Product / Process Change Notification (PCN)

PCN #: PCN_SwTASV_20180626

Affected Series: 4301x2xxx8x6

As a datasheet information amendment, Würth Elektronik will update a new parameter in the specification and correct one dimension mismatch.

BEFORE**AFTER**

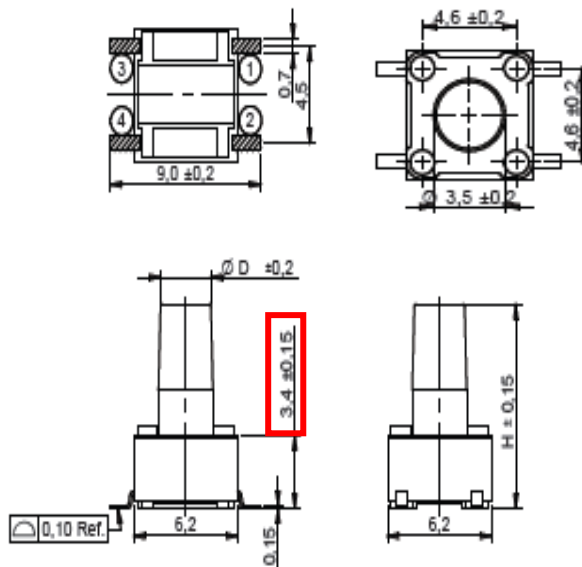
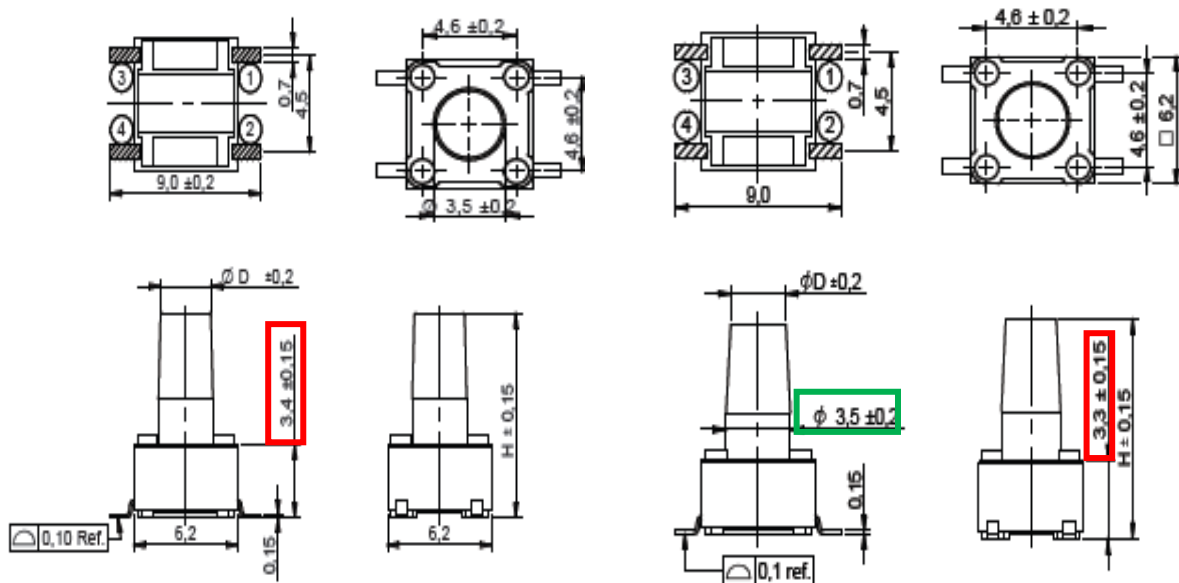
1. Adding the new parameter 3.5 ± 0.2 for the max. width of actuator.
2. Correcting the height of the frame because of a datasheet mismatch from 3.4 ± 0.15 to 3.3 ± 0.15 .
